**TOWN OF ROWLESBURG
PRESTON COUNTY, WEST VIRGINIA**

CRITICAL NEEDS SANITARY SEWER SYSTEM UPGRADES

ADDENDUM #2

THRASHER PROJECT #020-10136

SHEET No.
3

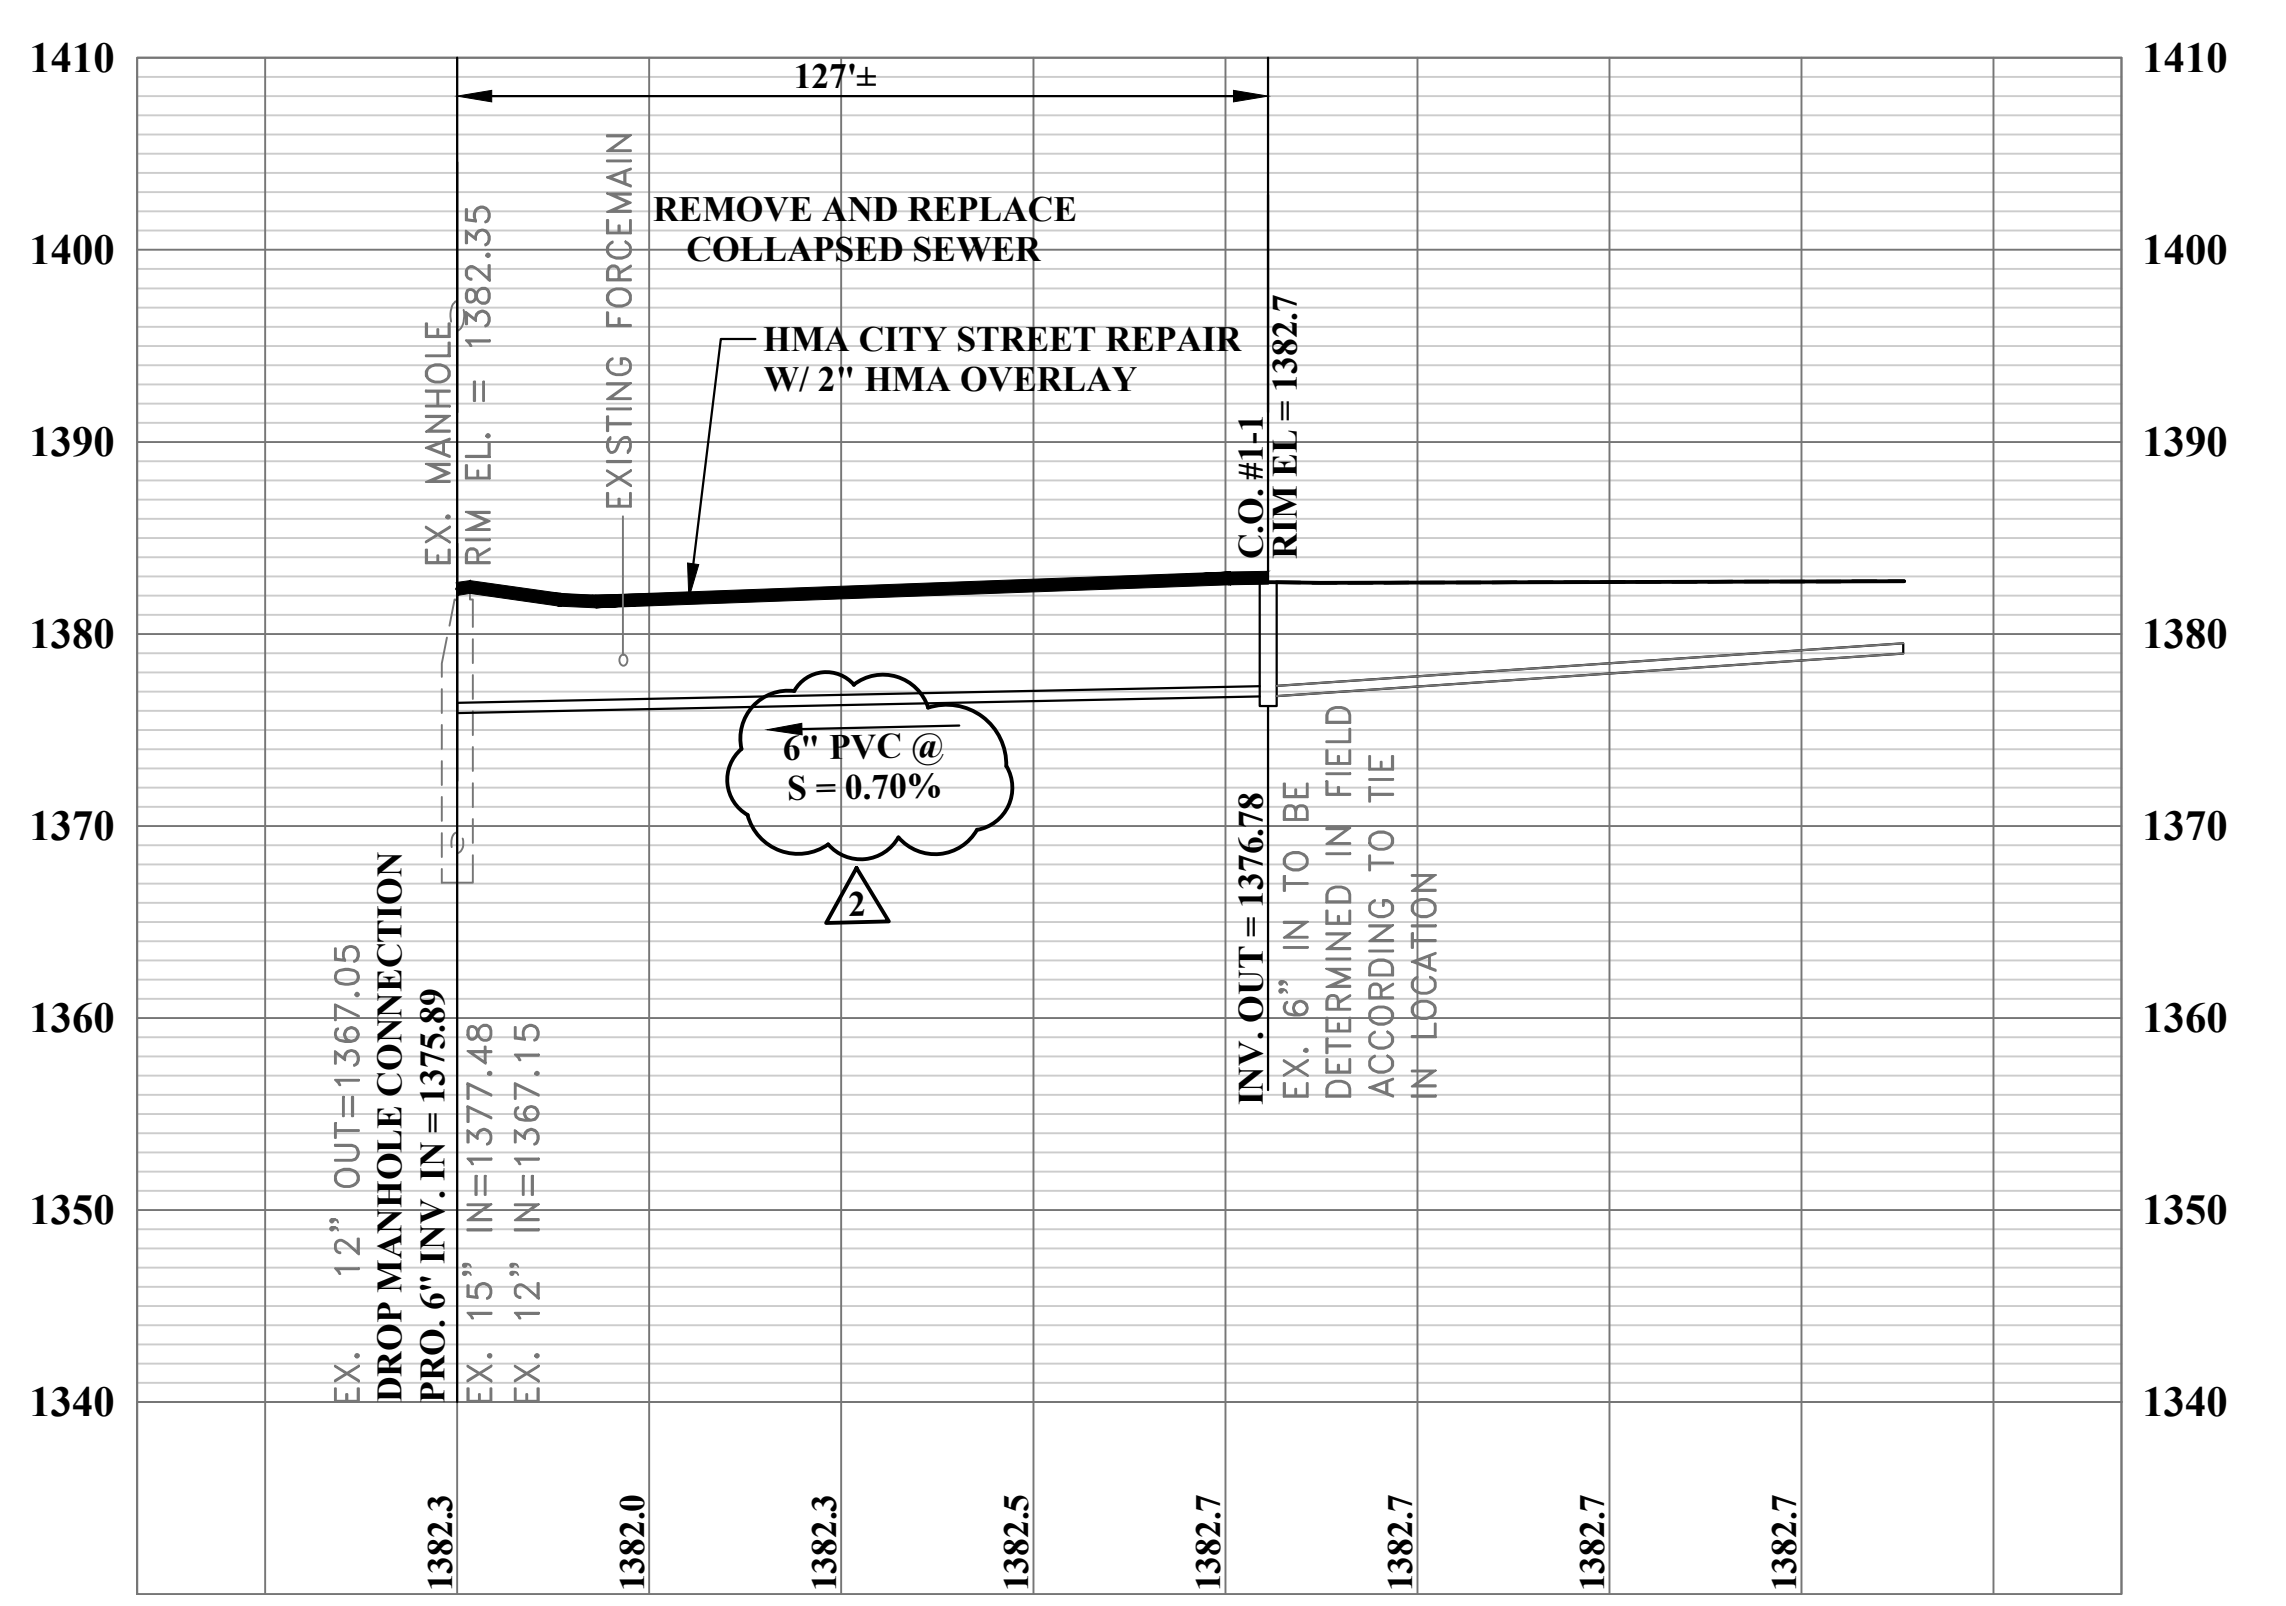
1. All piping in the Valve Vault shall be 4". See updated table on Sheet DET-5. The label on the reducer has been revised as "REDUCER (M.J.) AS NECESSARY". A reducer is not necessary for this project.
2. Gravity sewer pipe shall be 6" PVC SDR-35 on Coniff Street as shown on updated SHT-3

NO.	BY	DATE	DESCRIPTION
2	CT	6/24	UPDATED PIPE TYPE
